File In Section: Product Recalls
Bulletin No.: 10153
Date: June 2010

PRODUCT SAFETY RECALL

SUBJECT: Heated Windshield Washer Module Short Circuit – Permanently Disable and Remove Module

2182457

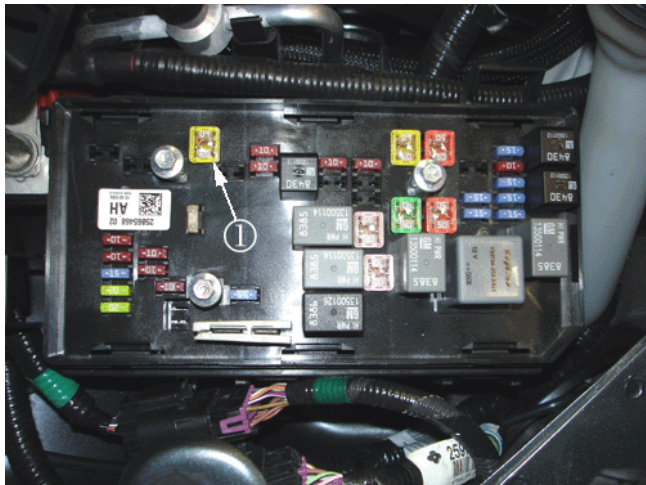
2. Locate the underhood bussed electrical center (UBEC) (1).

2476560

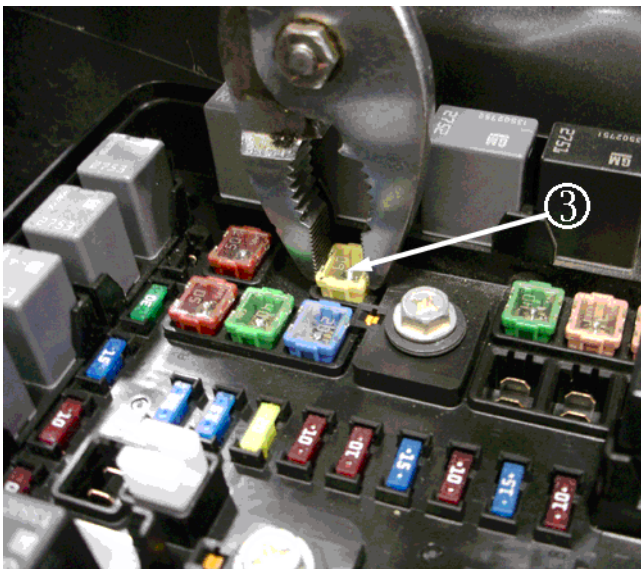
3. Locate the underhood busse electrical center (UBEC) (2).
4. Remove the UBEC cover (2) and locate the WSW/HTR 60 amp heated windshield washer fuse.

5. Remove the WSW/HTR 60 amp heated windshield washer fuse (3) using pliers.
6. Discard the WSW/HTR 60 amp heated windshield washer fuse (3).
7. Refer to *Windshield Washer Solvent Heater Removal* in this bulletin. After completing the *Windshield Washer Solvent Heater Removal* service procedure, proceed to step 8 in this section of the bulletin.
8. Connect the negative battery cable. Refer to *Battery Negative Cable Disconnection and Connection* in SI.
9. Test the operation of the windshield wiper system.
 - 9.1. Ensure the wiper system functions in low and high positions.
 - 9.2. Verify that the windshield wiper/washer switch functions. The windshield wiper system should provide wiper fluid to the windshield.

2006-2007 HUMMER H2

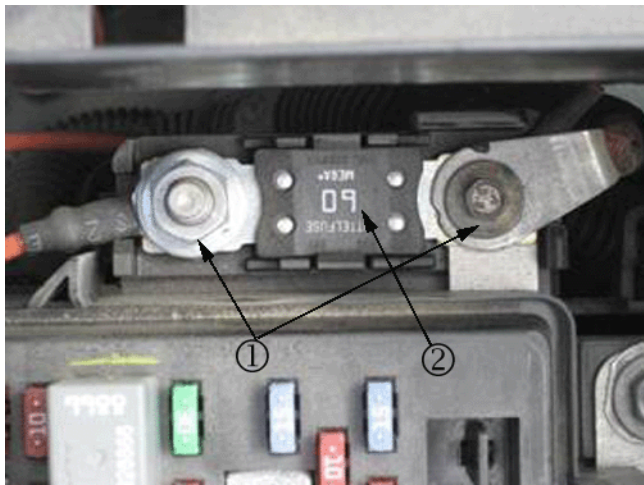
2. Locate the under-hood bussed electrical center (UBEC).
3. Remove the UBEC cover and locate the 60 amp heated windshield washer Mega fuse.

4. Remove the two nuts (1) for the Mega fuse (2). Refer to the picture.
5. Remove the 60 amp heated windshield washer Mega fuse.
6. Discard the 60 amp heated windshield washer Mega fuse.
7. Install the two nuts back into the two studs.
8. Refer to *Windshield Washer Solvent Heater Removal* in this bulletin. After completing the *Windshield Washer Solvent Heater Removal* service procedure, proceed to step 9 in this section of the bulletin.
9. Connect the negative battery cable. Refer to *Battery Negative Cable Disconnection and Connection* in SI.
10. Test the operation of the windshield wiper system.
 - 10.1 Ensure the wiper system functions in low and high positions.
 - 10.2 Verify that the windshield wiper/washer switch functions. The windshield wiper system should provide wiper fluid to the windshield.

2182446

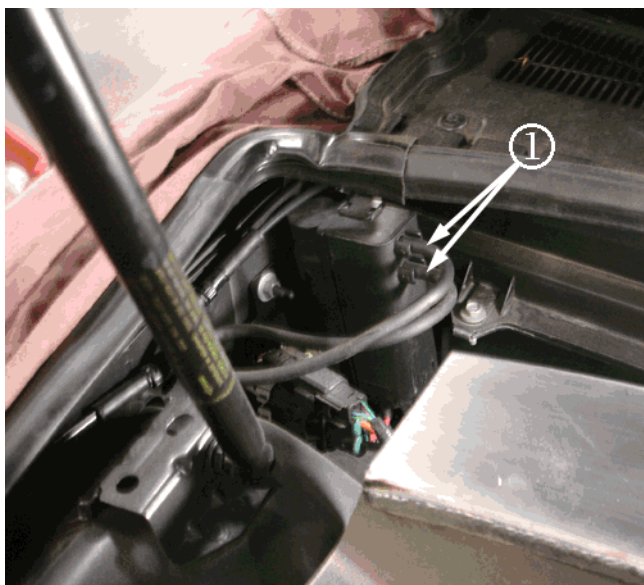
2. Locate the underhood bussed electrical center (UBEC).

3. Remove the UBEC cover and locate the 60 amp heated windshield washer fuse.

4. Remove the 60 amp heated windshield washer fuse using needle-nose pliers.
5. Discard the 60 amp heated windshield washer fuse.
6. Install the two relays removed in Step 4.
7. Refer to *Windshield Washer Solvent Heater Removal* in this bulletin. After completing the *Windshield Washer Solvent Heater Removal* service procedure, proceed to step 8 in this section of the bulletin.
8. Connect the negative battery cable. Refer to *Battery Negative Cable Disconnection and Connection* in SI.
9. Test the operation of the windshield wiper system.

2476554

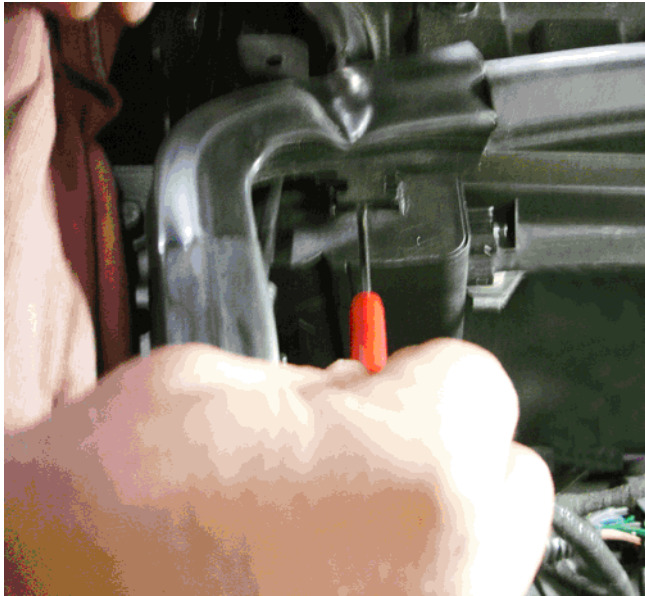
1. Disconnect the windshield wiper solvent inlet and outlet hoses (1) from the windshield washer solvent heater assembly and from the two plastic inlet and outlet windshield wiper solvent hoses.
- Note:** Do NOT remove the connector retention clips from the connectors. Do NOT remove the assembly bracket from the engine compartment.
2. Disconnect the two electrical connectors at the windshield washer solvent heater assembly.

2476559

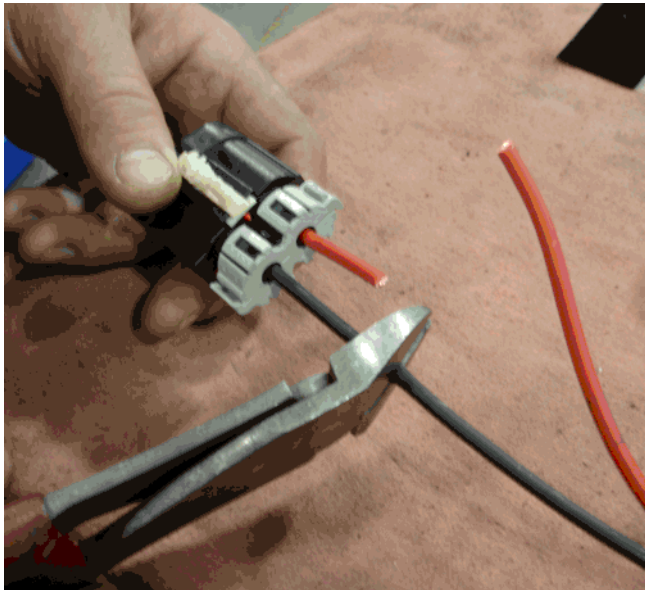
3. Remove the windshield washer solvent heater assembly from the assembly bracket using a small flat blade screwdriver.
4. Place the windshield washer solvent heater assembly on a work bench.

2476545

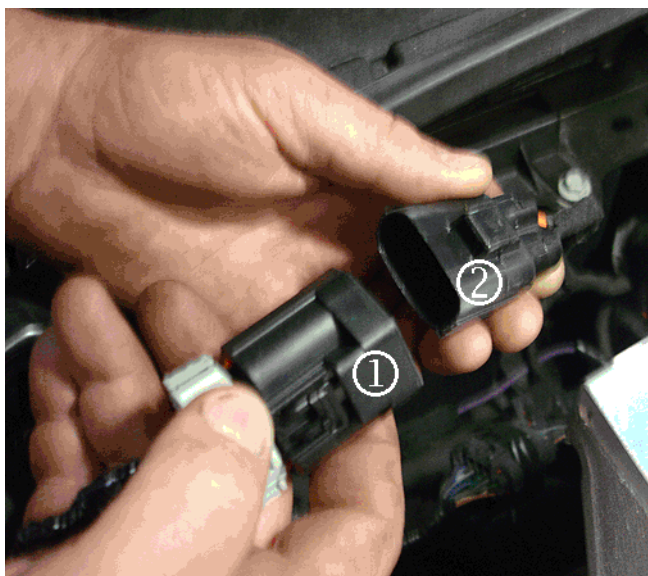
8. Wrap the large connector with two wires in electrical tape.

2476557

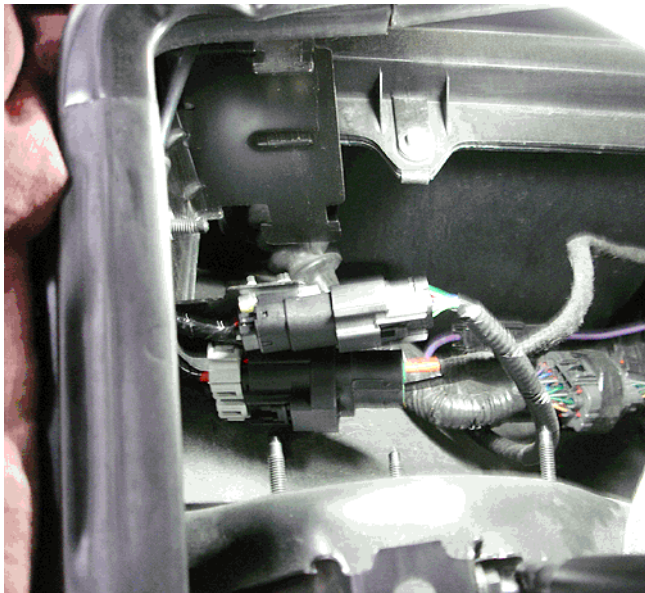
12. Connect the small five-wire connector (1) to the body harness (2).
